ADDENDUM NO. 7

**TO THE SPECIFICATIONS AND DRAWINGS
FOR CONSTRUCTION OF**

**High School / Middle School Complex
MECKLENBURG COUNTY, VIRGINIA**

S.D.E. Project #: 058-104-01-100

1 PARTIAL FIRST FLOOR PLAN - AREA A1 RELOCATE DOOR A125
 A111 SK-A37 1/8" = 1'-0"

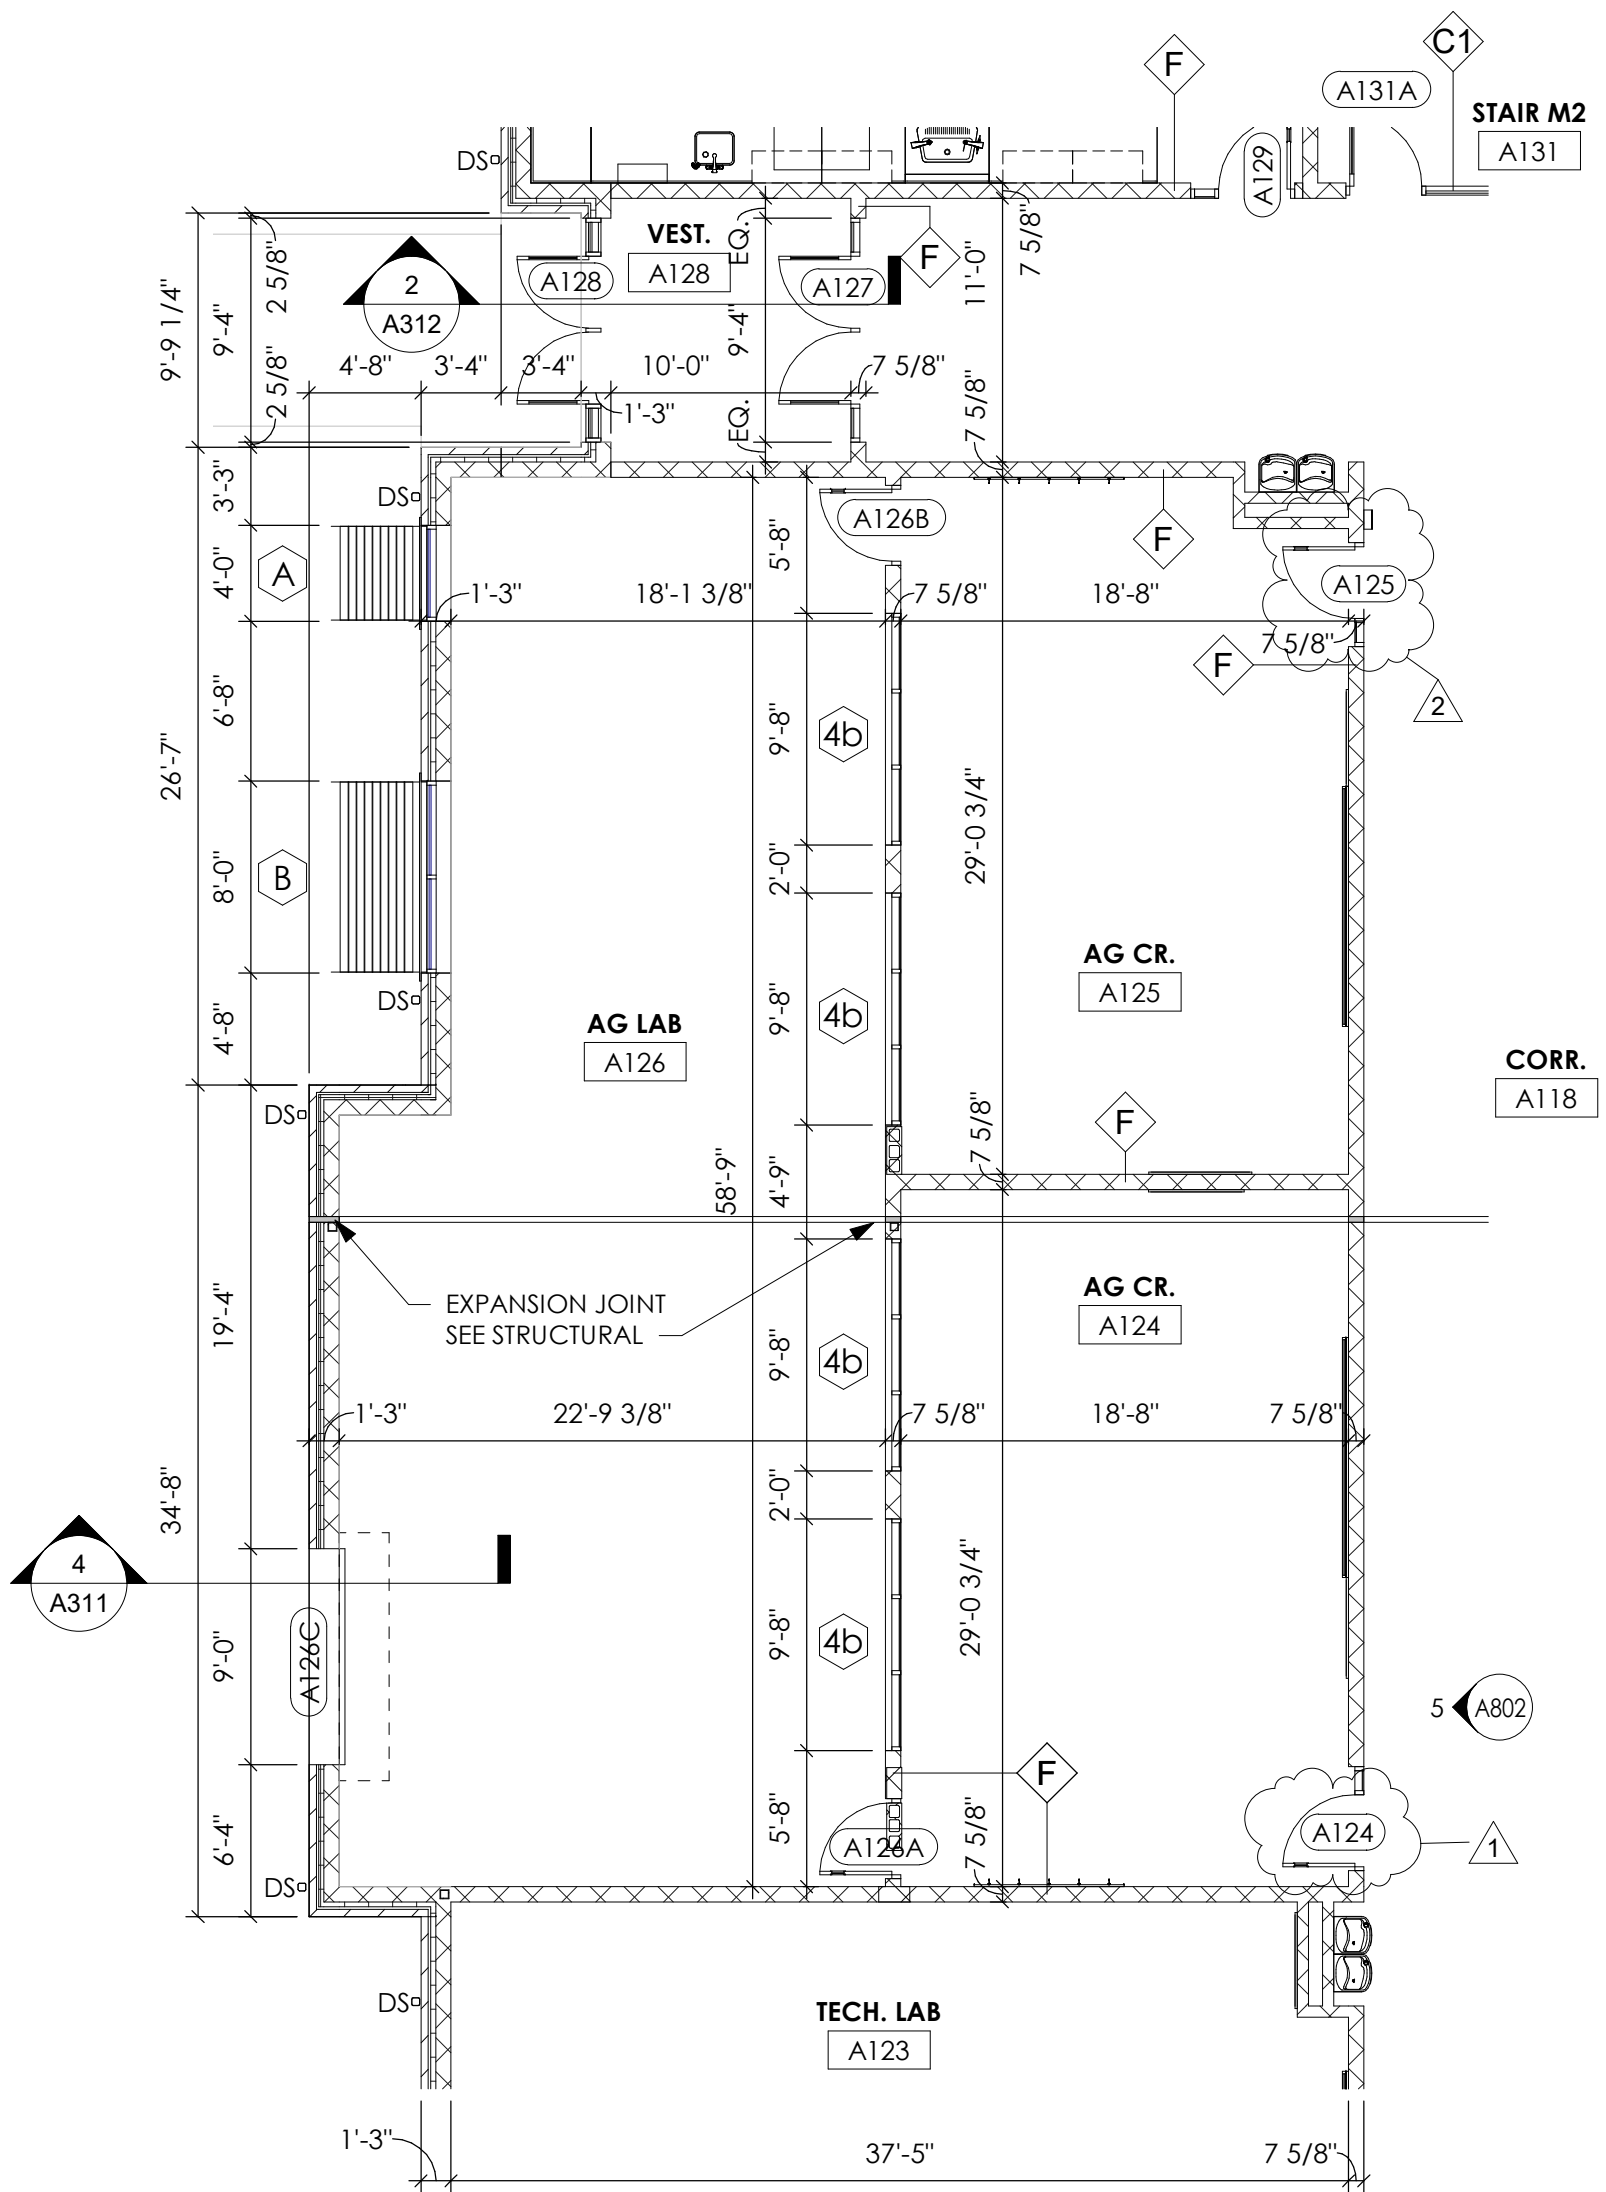
DRAWING A111

Partial First Floor plan Area "A", door modifications. See included Sketch SK-A37.
